# Access Compliance Report

## Public Rights-of-Way

Intersection ID: 50664	Main Street: CRAIGHILL_LN	Cross Street: WITHERS_RD	Location: SW
ADA ID: 0C45E6313F0F	Ramp Type: Perp	Initial Pass/Fail: Fail	Overall Compliance: No
Severity Score: 12.5			
Codes/Mitigation Info/Possible Solution		Field Measurements/Component Compliance

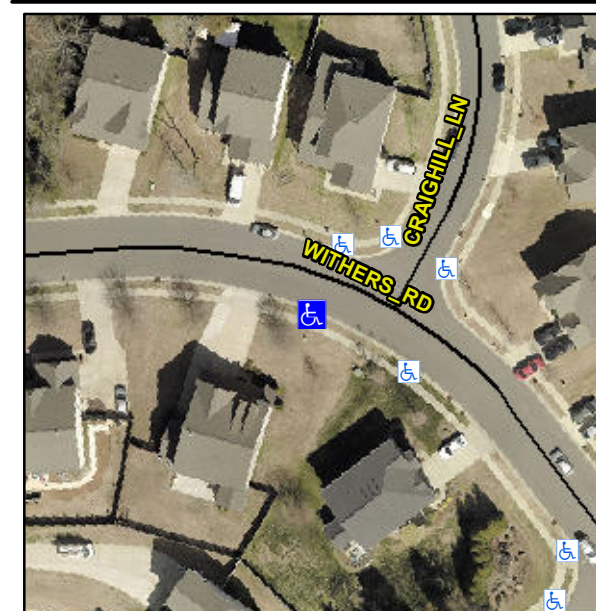
**Not Found, R304.2.2**

Compliance	Description	Data	Compliance	Description	Data
N/A	Ramp Length (in)	48.0	No	Ramp Slope (%)	8.7
Yes	Ramp Width (in)	48.0	Yes	Ramp XSlope (%)	2.0
N/A	Flare Type LT	N/A	N/A	Flare Type RT	N/A
N/A	Flare Slope LT (%)	N/A	N/A	Flare Slope RT (%)	N/A
N/A	Flare Traversable LT?	N/A	N/A	Flare Traversable RT?	N/A
N/A	Landing Length (in)	N/A	N/A	DWS Provided?	N/A
N/A	Landing Width (in)	N/A	N/A	DWS Contrast?	N/A
N/A	Landing Slope (%)	N/A	N/A	DWS Length (in)	N/A
N/A	Landing X Slope (%)	N/A	N/A	DWS Full Width?	N/A
N/A	Landing Curb? (Y/N)	N/A	N/A	DWS Offset (in)	N/A
N/A	Shared Landing?	N/A			
N/A	Gutter Ponding?	N/A	N/A	Gutter Slope (%)	N/A
N/A	Gutter Lip Ht (in)	N/A	N/A	Gutter X Slope (%)	N/A
N/A	Painted X Walk1?	No	N/A	Painted X Walk2?	N/A
	X Walk 1 Direction	To NE		X Walk 2 Direction	N/A
N/A	X Walk 1 Width (in)	N/A	N/A	X Walk 2 Width (in)	N/A
	X Walk 1 Slope (%)	3.1		X Walk 2 Slope (%)	N/A
	X Walk 1 X Slope (%)	1.9		X Walk 2 X Slope (%)	N/A

**Remove & Replace Entire Ramp.**
